**FINAL ENVIRONMENTAL IMPACT REPORT
FOR THE
OAK GROVE PLANNED UNIT DEVELOPMENT
(PUD-33)**

SCH #2004012013

February 9, 2007

COMMENT SUMMARIES AND RESPONSES

Figure 1-6: SLOPE ANALYSIS

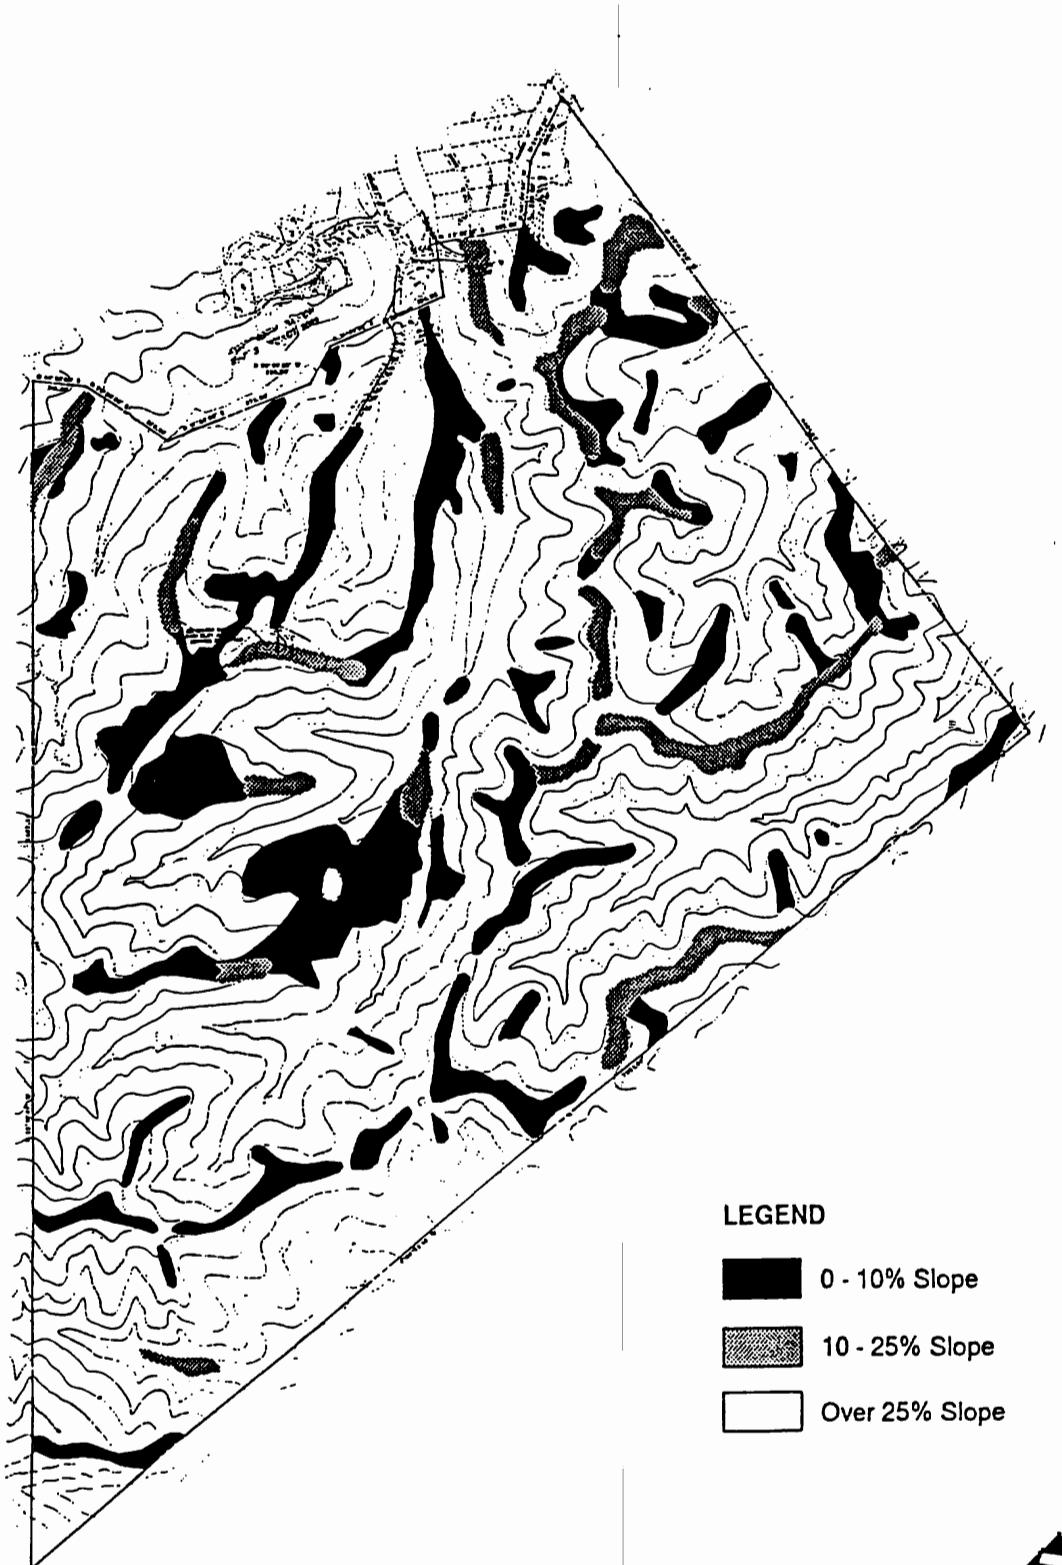
1. Steepness of terrain – The previous Kottinger Hills EIR discussed the steepness of terrain and the limitation of building on 25% or greater slopes. There is text discussing Slope Stability on p. 140; however, there are limited visual representations. Using the previous EIR from Kottinger Hills, please overlay the 98 and 51 site maps with the maps provided on Figure 1-6 Slope Analysis showing regions of the property from 0-10% slope, 10-25% slope and greater than 25% slope as well as Figure 1-7 Selected Site Constraints showing areas with landslides, steep slopes and high visual sensitivity. Figures are attached. C1

In addition, MacKay & Somps have prepared the report-scale exhibit that is provided at the end of this chapter, p. 97, presented as EIR Figure 40. This exhibit outlines the area proposed to be graded. Superimposed on the grading plan are shown (a) (outlined in blue) landslides within the grading limits that are proposed to be removed or repaired and (b) (outlined in yellow) landslides within the area encompassed by the 51-lot development but outside the area proposed for project grading.

21. Looking southeast from Bernal Residential Development

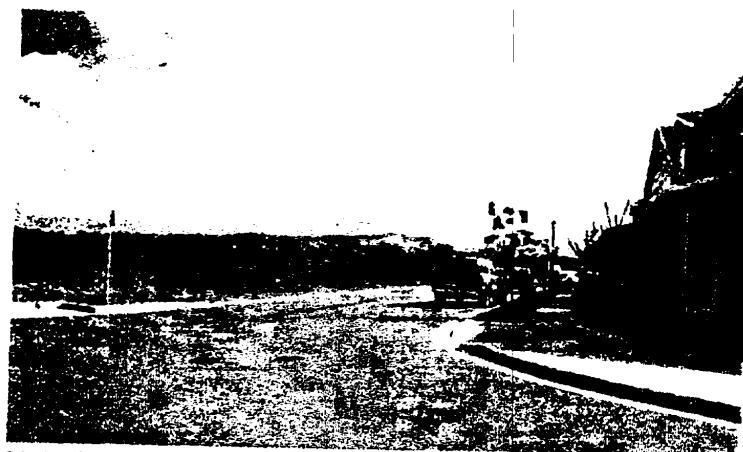
8. 2 inch by 3 1/2 inch photographic representations are inadequate to assess the project site. Please replace visual representations such as the one below (from Bernal Property which is visible from at least one cul de sac planned on the project site) with clear images taken in 50mm format and printed at least in 8.5 by 11 inch format with similar photographic quality as this one taken by a resident –

The "Oak Grove DEIR Visual Re-Print Portfolio" (January 2007) includes 11X17 inch sheets with existing visual character photo images presented in color at 7¼X4¼ inches. A total of 25 photos are included (Figures 7 through 9c). Copies of the portfolio have been provided to Planning Commission and City Council members. Copies are also available for public review at the Pleasanton Planning Department.

Figure 15a
VP 14 - Bernal Avenue
Oak Grove EIR

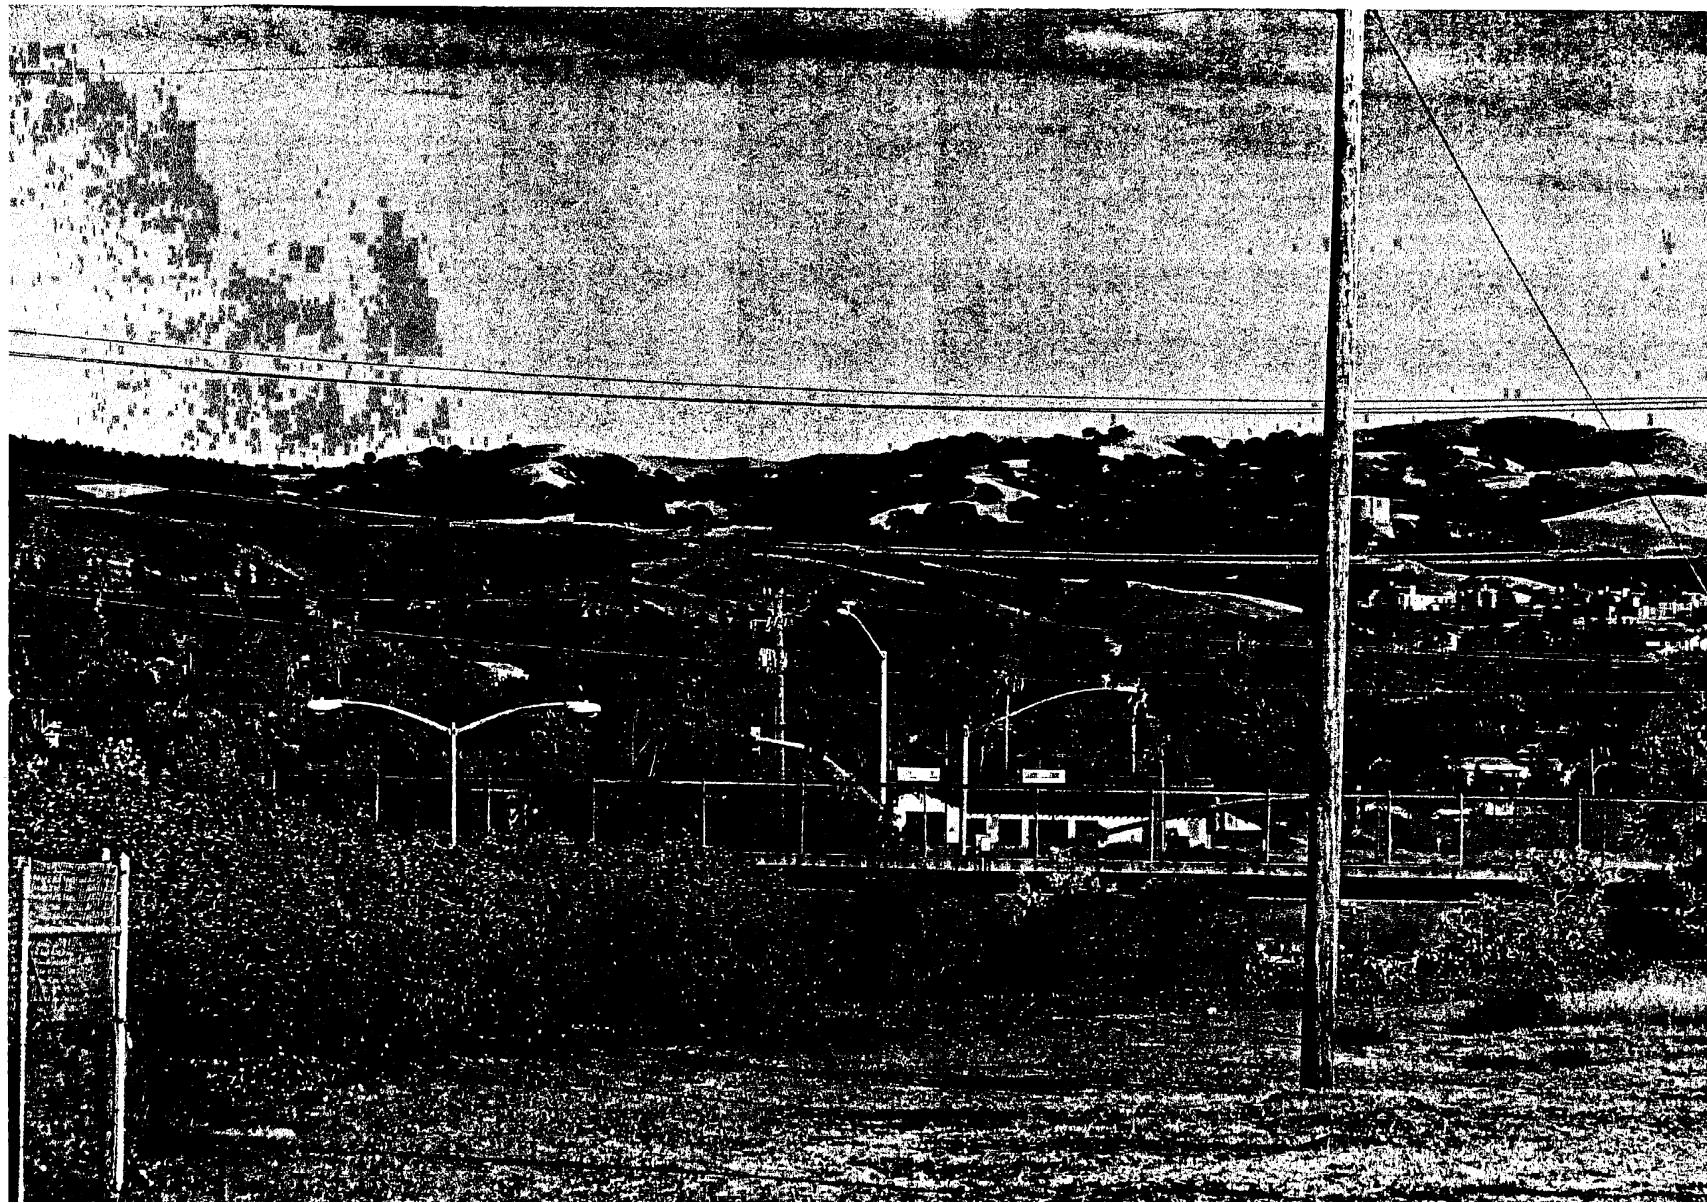
9. The Valley/Stanley/Bernal intersection photographs are blurry and at low resolution (see the gray squares in the roadway indicating low resolution) as is this image below. Please replace visual representations with more accurate representations (the Valley/Stanley/Bernal intersection is visible from almost all cul de sacs on the planned on the project site) with clear images taken in 50mm format and printed at least in 8.5 by 11 inch format with similar photographic quality as this one taken by a resident.
